10/567,134

Office Action Summary	Application No. 10/567,134	Applicant(s) IGARASHI ET AL.	
	Examiner ERNESTO GARCIA	Art Unit 3679

DETAILED ACTION

Fig. 1

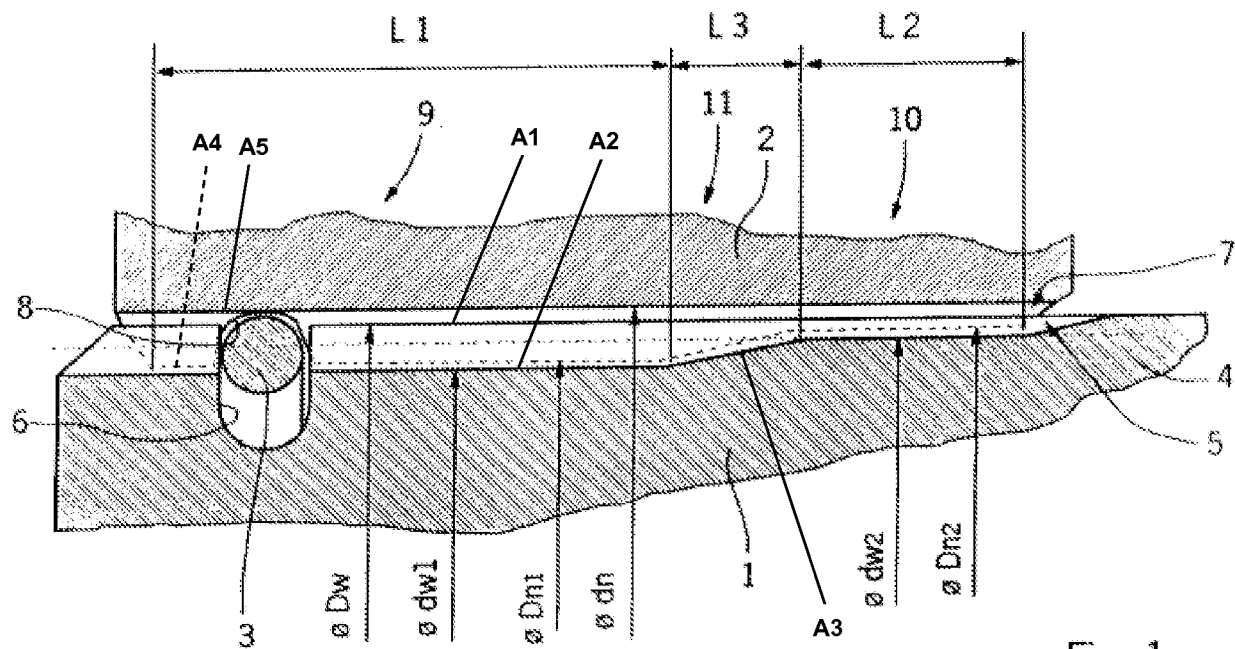
Regarding claim 1, Beigang discloses, in Figures 1 and 2, a mechanism comprising a shaft **1** and a hub **2**. The hub **2** is disposed around the shaft **1** while holding a shaft tooth section **5** formed on the shaft **1**. The hub **2** has a hub tooth section **7** in engagement with the shaft tooth section **5**. The shaft tooth section **5** has a crowned peak having a varying tooth thickness and a valley **A2** having an outside diameter varying from an end thereof toward a shaft shank of the shaft **1**. The hub tooth section **7** has a straight peak **A4** and a valley **A5**. The straight peak **A4** has a constant tooth thickness and an inside diameter varying from an end thereof toward the shaft shank. The valley **A5** of the hub tooth section **5** has a constant inside diameter in the axial direction of the shaft **1**.

Regarding claim 2, a changing point of the outside diameter of the valley **A2** of the shaft tooth section **5** and a changing point of the inside diameter of the peak **A4** of

the hub tooth section **7** are set in respective positions which are offset from each other in the axial direction of the shaft **1** (see towards the left side of Figure 1 which is the front of the joint).
